April 30, 1993
LD-93-072

SUBJECT: SYSTEM 80+ Supplemental Information

SYSTEM 80+™

SUPPORTIVE INFORMATION FOR NUCLEAR ISLAND (NI) STRUCTURES
(2.1.1)

FIGURE 3.8-5
SH. 1 OF 12

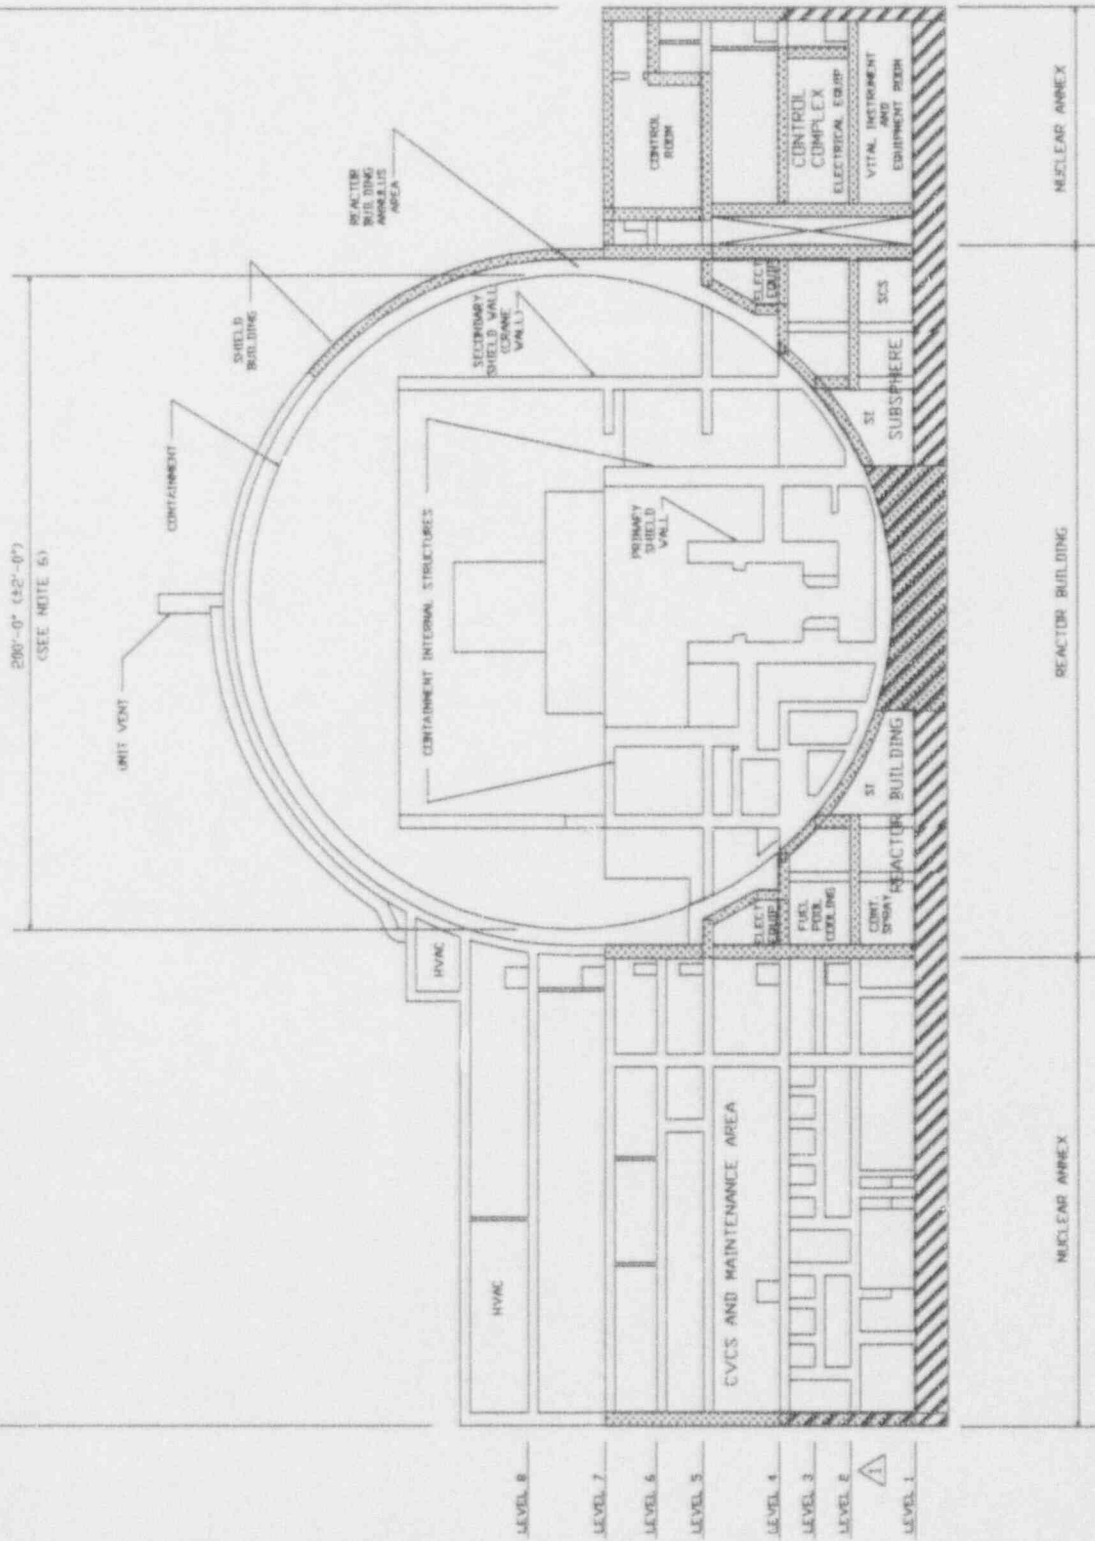
The ~~base configuration~~ ^{arrangement} of the Nuclear Island structures, which includes containment and defines critical dimensions, flood barriers, and fire barriers, is shown on Figure 3.8-5, Shs. 1-12.

The ~~arrangement~~ ^{configuration} of the Nuclear Island Structures, which includes the internal structure and defines critical dimensions, fluid barriers, and fire barriers, is shown on Figure 3.8-5, Shs. 1-12.

The ~~basic configuration~~^{arrangement} of the Nuclear Island Structures, which includes the reactor building and defines critical dimensions, flood barriers, and fire barriers, is shown on Figure 3.8-5, Shs. 1-12.
